Service bulletin # HK2010-01 June 2010

Models: HKTS2, HKTS5, HKTS6, HKTS7, HKTS8, HKTS15

Subject: Repetitive Popping/Thumping Sound When In Standby

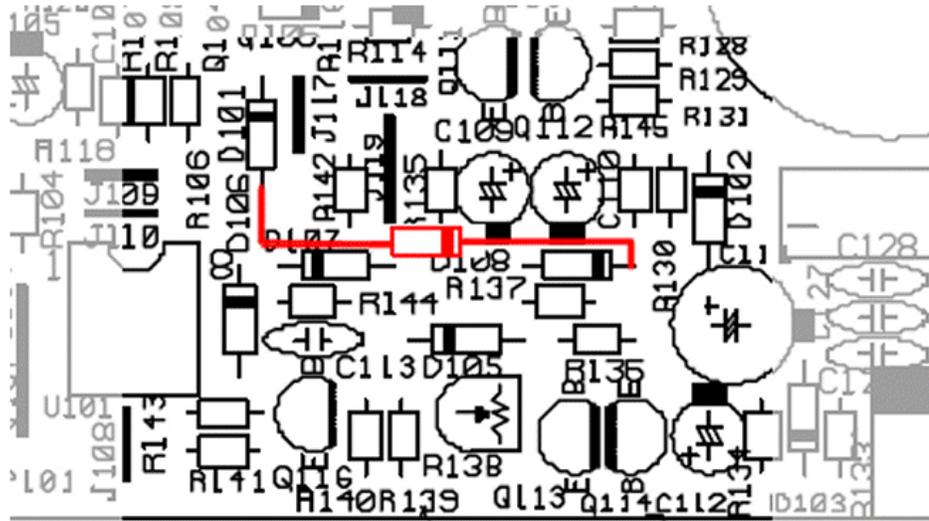
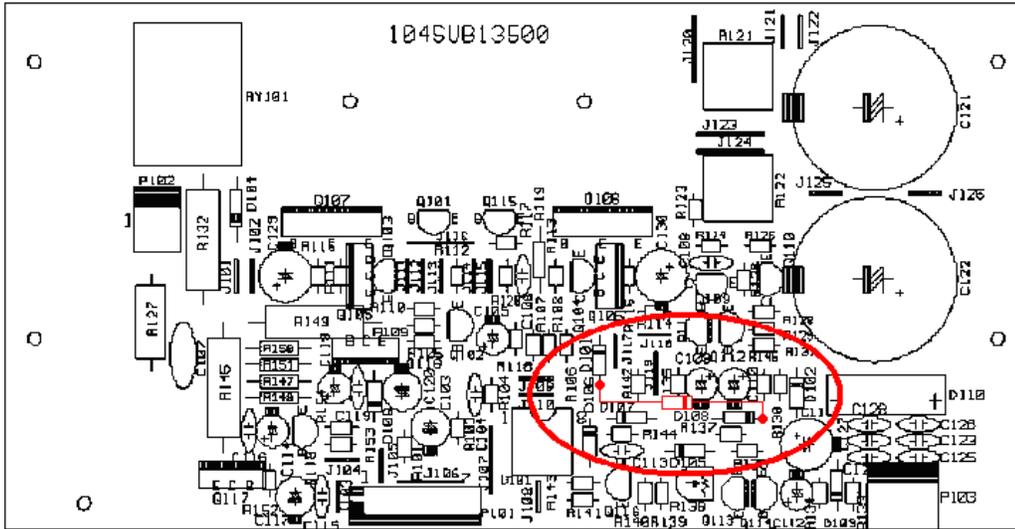
**In the event you receive an HKTS2, HKTS5, HKTS6, HKTS7, HKTS8, or HKTS15 Subwoofer with the complaint “there is a repetitive popping or thumping sound when in the standby mode”, follow the procedure below:**

Synopsis: Replace U301; if problem remains remove R263 and add new 1N4148 diode

- 1) Remove the amplifier from the cabinet
- 2) Locate the limiter board; remove adhesive from rear side of the PCB so you can access U301.

- b) Add a new 1N4148 diode (part# 13-0482 or equivalent) to the power amp PCB. Connect the Anode to the Anode of D101 and the Cathode to the Cathode of D108 (See figure below).
- c) Replace the amplifier and test the subwoofer
